RE: PETITION NO. 1479 – Bloom Energy Corporation petition for a declaratory ruling, pursuant to Connecticut General Statutes §4-176 and §16-50k, for the proposed construction, maintenance and operation of a customer-side 1.5-megawatt fuel cell facility and associated equipment to be located at the NBC Sports Group building, 1 Blachley Road, Stamford, Connecticut.

Petition No. 1479 Bloom Energy Corporation NBC Sports Group 1 Blachley Road, Stamford, CT

Interrogatories - Set 1

Exhibit 2: Revised

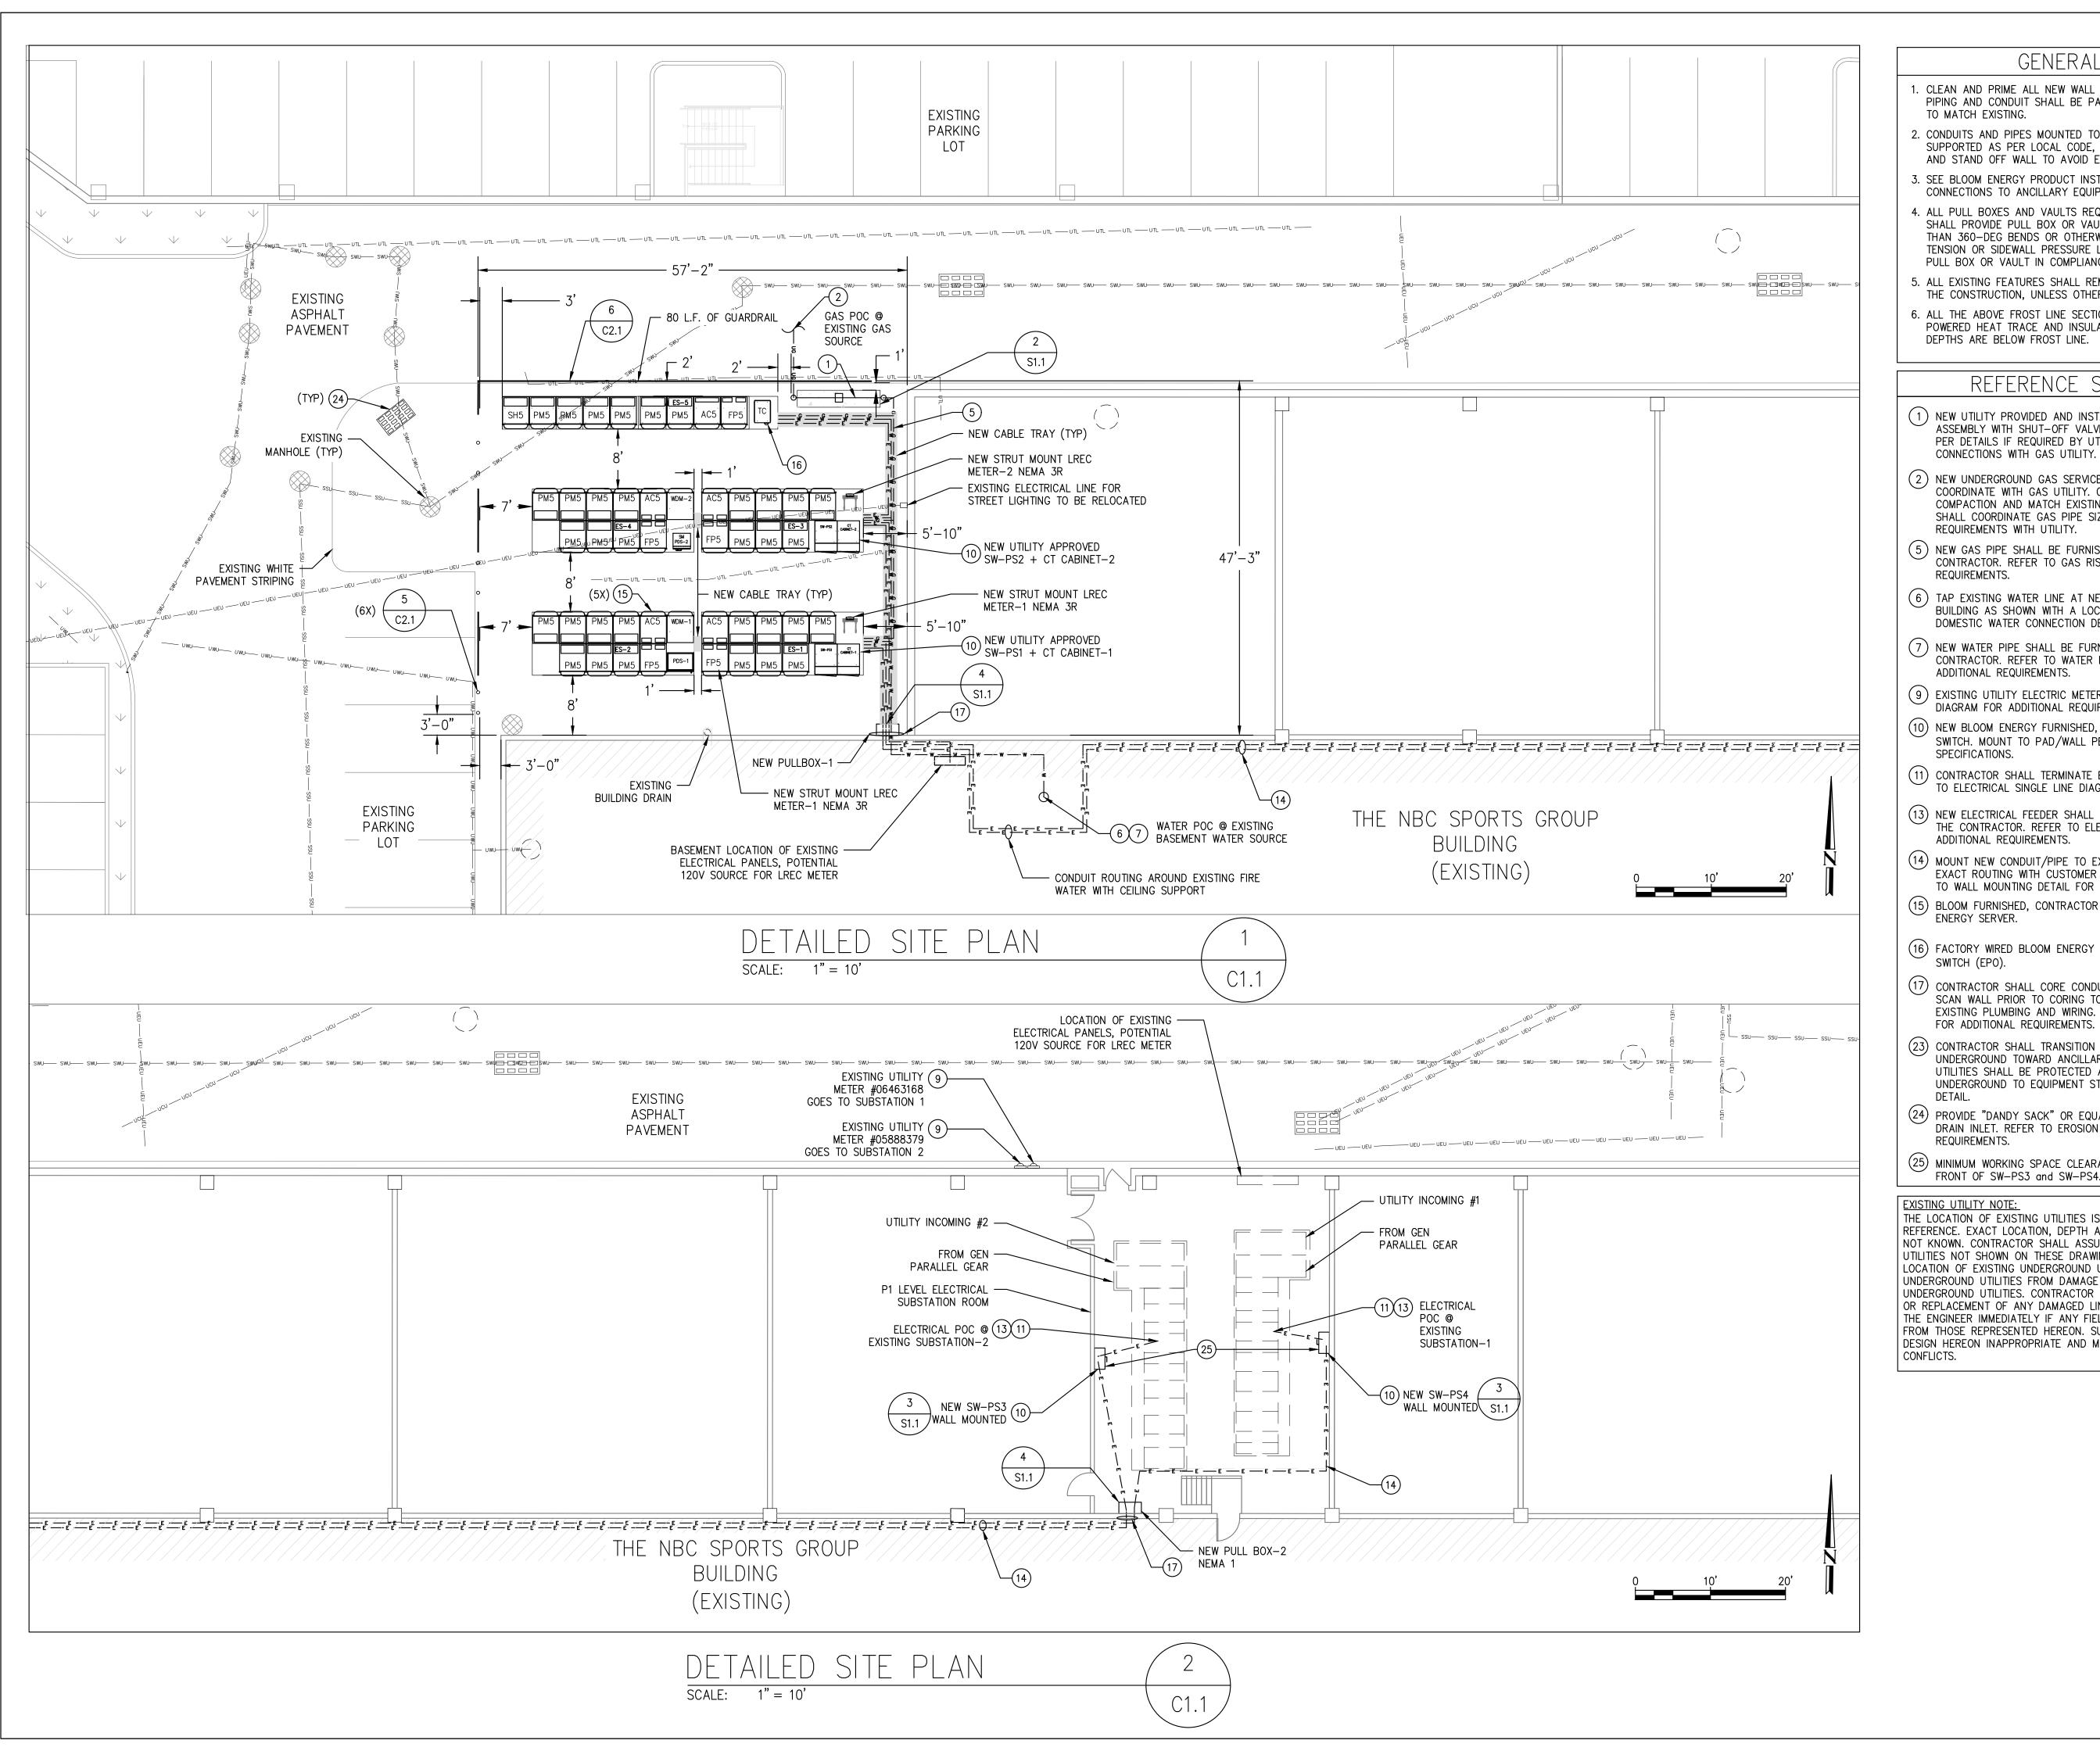
4. Referring to Petition Exhibit 2, clarify the location of the electrical service and revise Exhibit 2 if necessary.

Response: The electrical service point of connection will be at the existing substation service connection within the NBC Sports Group Building, as detailed in Exhibit 3. A revised Exhibit 2 is attached.

DETAILED SITE PLAN

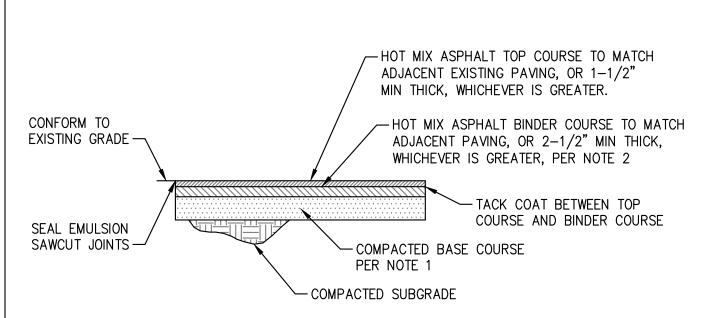
5. What security measures are proposed for the facility (e.g., fencing, bollards, locks)? Provide site plan detail.

Response: Based on recent consultation with Eversource, Bloom will install a guardrail on the north and west sides of the energy server installation to protect against vehicular damage. Please see the attached detailed site plan and detail sheet #1. (Attachment 3)
